# **Attachment B**

**Inspection Report  
6 Central Park Avenue, Chippendale**

**Council Investigation Officer Inspection and Recommendation Report; Clause 17(2) Part 8 of Schedule 5 of the Environmental Planning and Assessment Act 1979 (the Act)**

**RE: INSPECTION REPORT  
IGLU STUDENT ACCOMMODATION  
6 CENTRAL PARK AVENUE CHIPPENDALE ("the premises")**

Image 1 - quarter-turn isolation valves

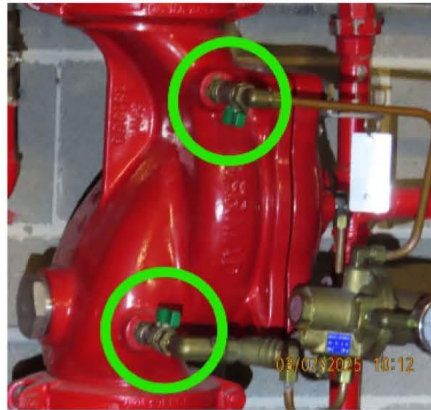
- e An egress door that does not permit occupants to evacuate the premises may place evacuees in an unsafe situation.
- f The PO-PRV installed within the combined sprinkler/hydrant pumproom and fire isolated stairways, incorporates quarter-turn isolation valves on the supply and sensing pipes for the pilot valve (Image 1 below).

- i. When turned to the 'OFF' position, the combined hydrant and sprinkler system will not operate as required. The complementary fire safety measures, such as occupant warning, zone smoke control and automatic fire brigade response will not automatically operate.

- ii. Clause 2.13 of AS2118.6-2012 requires fault monitoring of isolating valves either side of a pressure reduction valve.
- g As a result of a combined sprinkler and hydrant system not operating following a fire at a premises elsewhere, FRNSW released a position statement, [Pilot operated pressure reduction valve \(PO-PRV\) installation](#).

1. Restore the Smoke Detection and Alarm Systems (SDAS) by removing all faults and isolations associated with the system.
2. Repair the egress doors within the building to open without undue force.
3. Rectify the Pilot Operated Pressure Reduction Valves (PO-PRV) to prevent isolation of the firefighting system by either,
  - a. Removing the quarter-turn isolating valve from the pilot sensing and supply pipe, or
  - b. Locking in the open position and monitoring the quarter-turn isolating valve in accordance with the relevant Australian Standard, or

- c. Replacing the POPRV with a pressure reducing valve that does not have any isolating valve on the pilot tube.

Image 1 - quarter-turn isolation valves

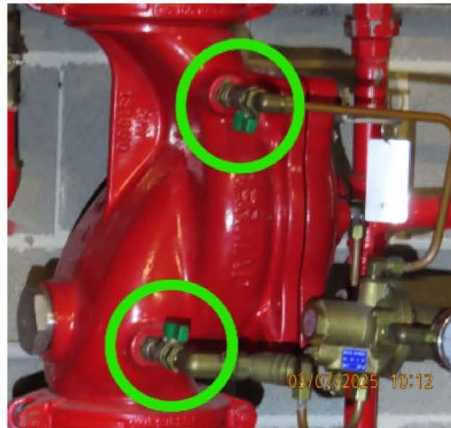
- e An egress door that does not permit occupants to evacuate the premises may place evacuees in an unsafe situation.
- f The PO-PRV installed within the combined sprinkler/hydrant pumproom and fire isolated stairways, incorporates quarter-turn isolation valves on the supply and sensing pipes for the pilot valve (Image 1 below).

- i. When turned to the 'OFF' position, the combined hydrant and sprinkler system will not operate as required. The complementary fire safety measures, such as occupant warning, zone smoke control and automatic fire brigade response will not automatically operate.

- ii. Clause 2.13 of AS2118.6-2012 requires fault monitoring of isolating valves either side of a pressure reduction valve.
- g As a result of a combined sprinkler and hydrant system not operating following a fire at a premises elsewhere, FRNSW released a position statement, [Pilot operated pressure reduction valve \(PO-PRV\) installation](#).

1. Restore the Smoke Detection and Alarm Systems (SDAS) by removing all faults and isolations associated with the system.
2. Repair the egress doors within the building to open without undue force.
3. Rectify the Pilot Operated Pressure Reduction Valves (PO-PRV) to prevent isolation of the firefighting system by either,
  - a. Removing the quarter-turn isolating valve from the pilot sensing and supply pipe, or
  - b. Locking in the open position and monitoring the quarter-turn isolating valve in accordance with the relevant Australian Standard, or

- c. Replacing the POPRV with a pressure reducing valve that does not have any isolating valve on the pilot tube.
